<b>Property Location &amp; Assessor's Parcel Numbers:</b>	<b>845 Embarcadero (Development of Parcel B) 018 046500219</b>
<b>Proposal:</b>	To construct a residential and commercial mixed-use development for an 8-story, 241 residential unit with a ground-level retail area of approximately 3,000 square feet and parking garage on a 1.54 acres vacant lot. The site is located in Parcel B of the Final Development Plan for the Brooklyn Basin.  <i>NOTE: On June 22, 2016, the Design Review Committee reviewed this application and recommended the applicant to make design modifications to the project. The Committee asked the applicant to return to the Design Review Committee meeting for further review.</i>
<b>Applicant/ Phone Number:</b>	Deborah Tu / (510) 251-9284 or (510) 251-9270
<b>Property Owner:</b>	ZOHP-1, LLC
<b>Case File Number:</b>	<b>PUD06010-PUDF03</b>
<b>Planning Permits Required:</b>	Regular Design Review for new construction.

**PROJECT SUMMARY**

**PUD06010-PUDF03**  
**845 Embarcadero**  
**Brooklyn Basin**

### **PROJECT REVISIONS**

**GROUND LEVEL**  
SCALE: 1" = 40'

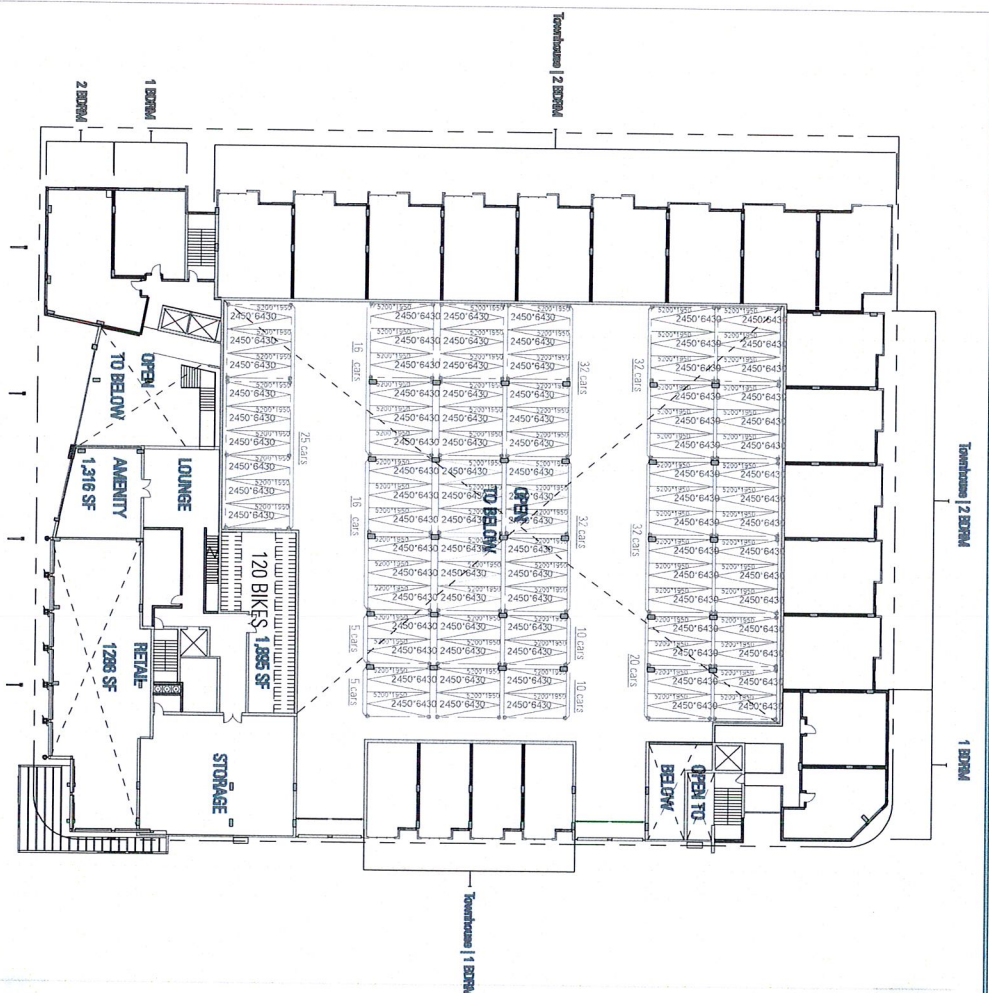
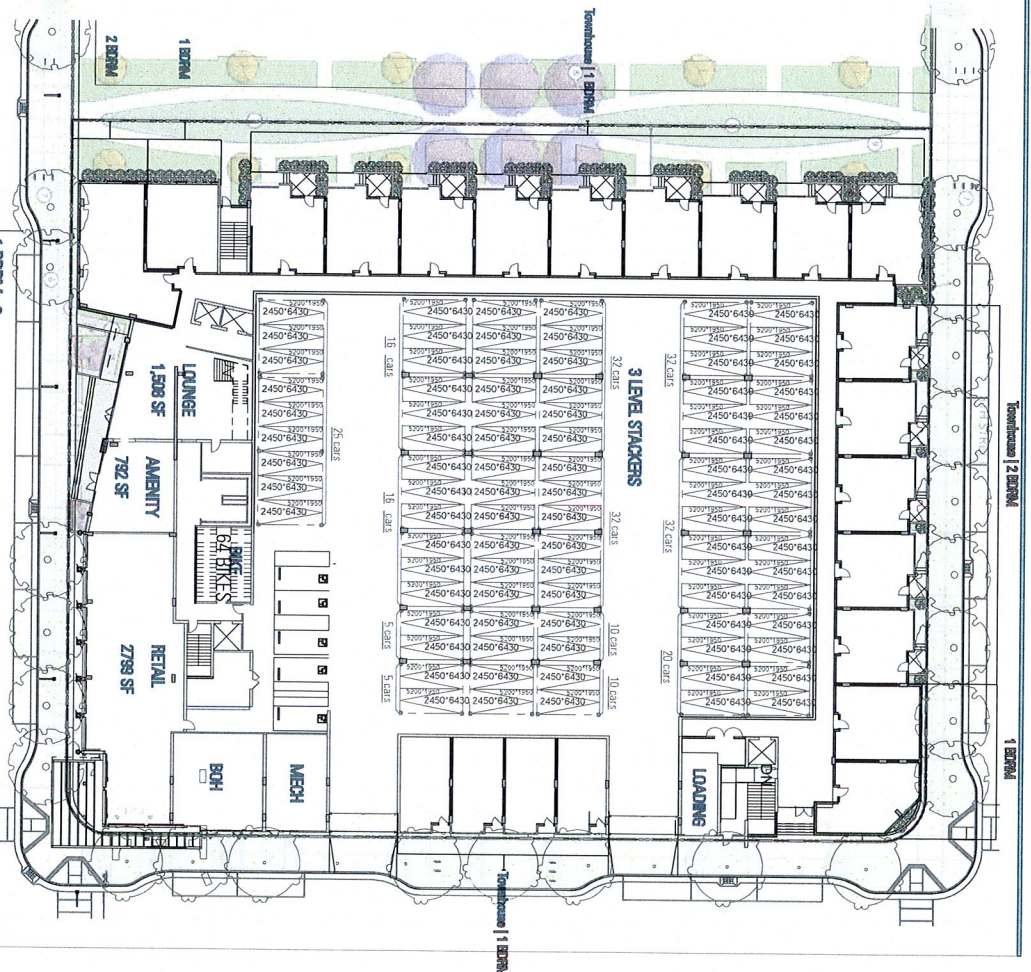
- 2) Ground-floor residential windows need to be at least 48 inches above sidewalk level or the plans need to include design elements for screening to provide privacy from streets.

- 8) Show additional bicycle parking areas inside and outside the building.

*“The 4 units on Clinton Lane with direct access to the public sidewalk will have a raised window sill to a minimum of 18” and opaque glass to a minimum of 48”. Unit Front Glass Doors will also have Opaque Glazing and all units will have window coverings. As shown on sheet 14.*

*“Outside bicycle parking has been identified on the Phase I FDP. Opportunities for enhanced bicycle parking at the street level adjacent to the commercial/retail use exist depending on the tenant. Secured bicycle parking will be installed inside the building on the first floor and the second floor mezzanine as shown on sheet 10.”*

**LANDSCAPE PLAN**

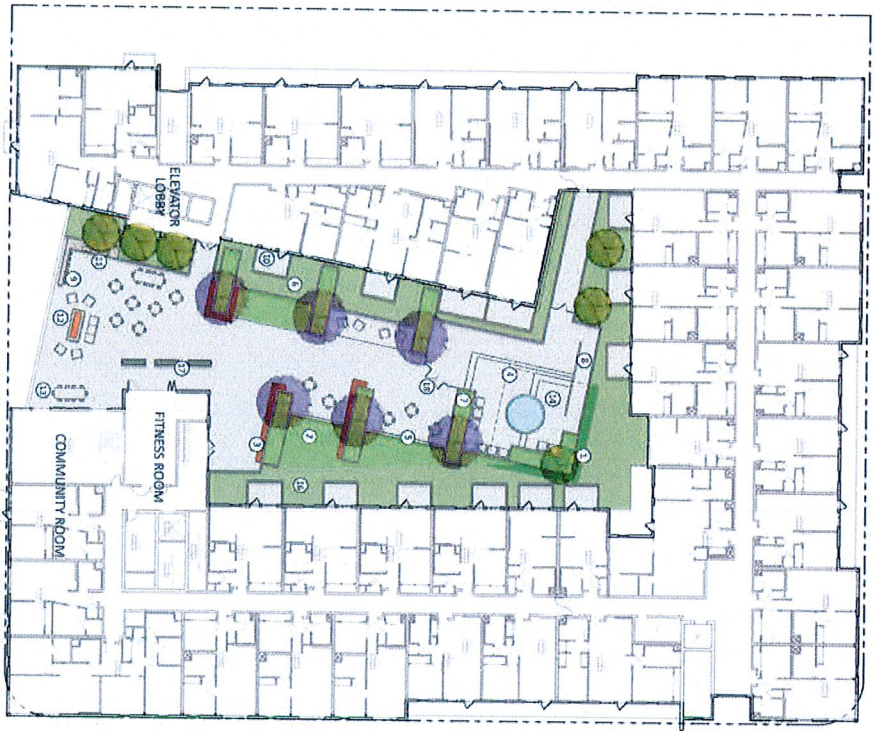
- d) The plans do not show significant changes to break up the continuous pattern of the balconies.
- e) The plans show a more detail landscaping plan along the ground-floor residential entries and public pathway including in the podium and rooftop, and new street trees around the property.

*“Additional landscaping has been added along the unit entries at the mews to better create a buffer between the public and private uses in the building. The additional landscaping in the mews is detailed. On page 10 & 25 and a perspective added on page 15.”*
